**HISTORIC PRESERVATION BOARD
CITY OF PORTLAND, MAINE**

**WORKSHOP
17 BLYTH COURT**

TO: Chair Sheridan and Members of the Historic Preservation Board
FROM: Rob Wiener, Preservation Compliance Coordinator
DATE: June 12, 2020
RE: June 17, 2020 **SECOND WORKSHOP – Third Floor Addition**

WORKSHOP
34 SPRUCE STREET

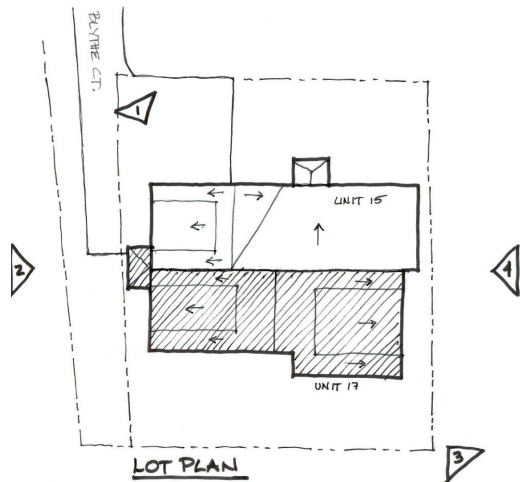
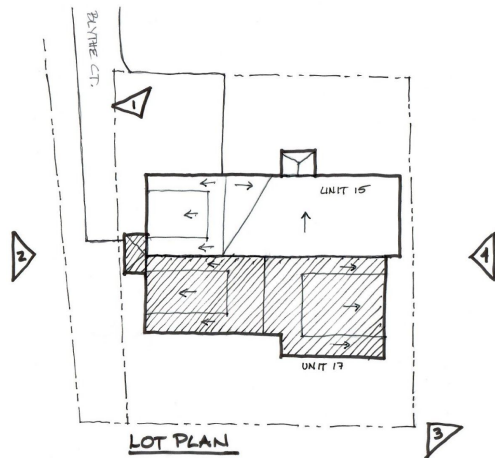
Although the May 20 staff report expressed skepticism that a flat-roofed third floor addition could be a compatible solution that wouldn't overwhelm the existing building, further exploration at the workshop and since then led staff to urge the applicants to propose the option as a possible solution to the design challenges posed by the program goals and existing circumstances. Staff still believes that simple geometry and modest massing are important, and suggests that perhaps the key question with the current proposal is whether the massing and scale of the simple box would be overwhelming for the existing structure to which would be joined or whether the simplicity would mitigate the scale.

Though there is no way to add a third floor without creating significant disparity in the height of the two sides of the duplex, staff notes that the simple form proposed builds on geometry that already exists at 17 Blyth. The proposed addition maintains that distinction in the geometric characters of the two sides of the duplex, leaving room for the architect and the Board to consider how much common design language should be employed between the two units, to balance integration and compatibility with differentiation and distinct characters.

roof of 15 Blyth, on the gabled addition proposed at the first workshop (now a moot point, with the current proposal.) Staff notes that most of the proposed third floor windows follow patterns found on the lower floors, but asks the Board to consider whether the mulled window on the east face of the third floor addition is too similar to the shed dormer at 15 Blyth.

Other details that will be present in a more complete set of drawings, such as fully rendered window trim, corner boards, and friezes may help influence the success of the design. Board members might again consider, for example, whether retaining the cornice band between the second floor and the proposed third floor would be beneficial.

In terms of the scale and massing of the currently proposed concept, staff suggests that the new addition will change somewhat the relationship of the property to the immediate context, but at approximately 30' high it will not be a harmful change for the neighborhood to absorb. This effect would be difficult to clearly estimate without more renderings, but perhaps Board members will want to comment on the compatibility of the proposal with the context.
